DEVELOPMENT APPLICATION - DA/2233/2010 – PROPOSED RETIREMENT VILLAGE
AT NO. 153 AND 153A MARMONG STREET MARMONG POINT

RESPONSE TO LMCC's REQUEST FOR ADDITIONAL INFORMATION 28 SEPTEMBER 2012

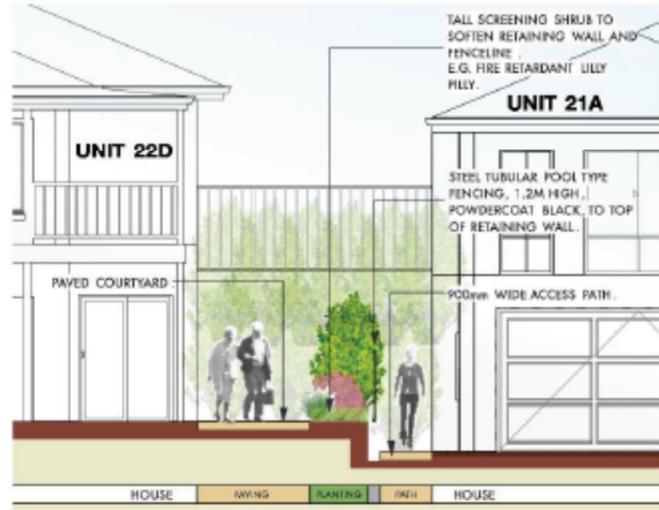
ISSUE RAISED BY LMCC	RESPONSE
<p>levels.</p>	
<p>Long street elevations have not been provided. This would assist in determining the relationship of the dwellings to each other.</p> <p>Insufficient sections through the development have been provided. Sections through the development would assist with determining the relationship of dwellings to each other as well as the roads and public spaces.</p>	<p>The architectural and landscape plans clearly demonstrate how proposed dwellings relate to each other including provision of private open space, landscaping, fencing and retaining walls where necessary. It is noted that FFL's of each dwelling, setback of dwellings to the street, distance between dwellings, location of visitor parking including disabled parking and width of roads have been incorporated onto the site plan (A102) prepared by Peter Dalton Architects Pty Ltd.</p> <p>Street elevations have been provided to demonstrate views along a typical street and the relationship between dwellings. Good separation is provided between dwellings for the provision of landscaping and to minimise any potential amenity impacts. A variety of front facades have been used which incorporate openings and patios or balconies with varied roof forms to create an appealing streetscape. These street elevations also depict natural ground level as well as finished floor levels of each dwelling to demonstrate the fill that will be required to be positioned in some parts of the site. The landscape plans include east west sections to demonstrate street landscaping including street trees, mass plantings, etc., the provision of retaining walls, courtyards with associated landscaping, level changes associated with the development and the relationship with the perimeter APZ and also pocket parks. Refer to Section BB below for further details.</p>
